Access Compliance Report Public Rights-of-Way (Curb Ramps)

Intersection ID: 15195 Main Street: ALBEMARLE_RD Cross Street: FARM_POND_LN Location: N

ADA ID: 8FF73DFFAB09 Ramp Type: MedianPerp Initial Pass/Fail: Fail Overall Compliance: No Severity Score: 10

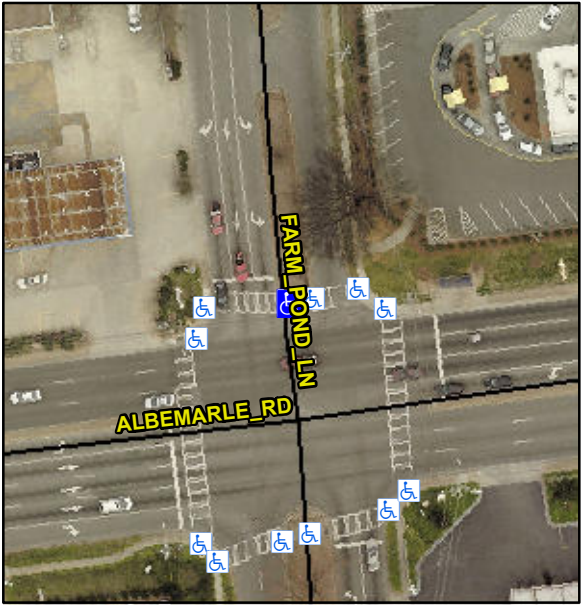
PROW/ADA:
Not Found, R304.5.1, R304.5.3

Compliance	Description	Data	Compliance	Description	Data
N/A	Ramp Length (in)	58.0	Yes	Ramp Slope (%)	6.8
No	Ramp Width (in)	41.0	No	Ramp XSlope (%)	2.7
N/A	Flare Type LT	N/A	N/A	Flare Type RT	N/A
N/A	Flare Slope LT (%)	N/A	N/A	Flare Slope RT (%)	N/A
N/A	Flare Traversable LT?	N/A	N/A	Flare Traversable RT?	N/A
N/A	Landing Length (in)	N/A	N/A	DWS Provided?	N/A
N/A	Landing Width (in)	N/A	N/A	DWS Contrast?	N/A
N/A	Landing Slope (%)	N/A	N/A	DWS Length (in)	N/A
N/A	Landing X Slope (%)	N/A	N/A	DWS Full Width?	N/A
N/A	Landing Curb? (Y/N)	N/A	N/A	DWS Offset (in)	N/A
N/A	Shared Landing?	N/A			
N/A	Gutter Ponding?	N/A	N/A	Gutter Slope (%)	N/A
N/A	Gutter Lip Ht (in)	N/A	N/A	Gutter X Slope (%)	N/A
N/A	Painted X Walk1?	Yes	N/A	Painted X Walk2?	N/A
	X Walk 1 Direction	To W		X Walk 2 Direction	N/A
N/A	X Walk 1 Width (in)	113.0	N/A	X Walk 2 Width (in)	N/A
	X Walk 1 Slope (%)	1.8		X Walk 2 Slope (%)	N/A
	X Walk 1 X Slope (%)	1.7		X Walk 2 X Slope (%)	N/A

Possible Solutions:
Remove & Replace Entire Ramp.
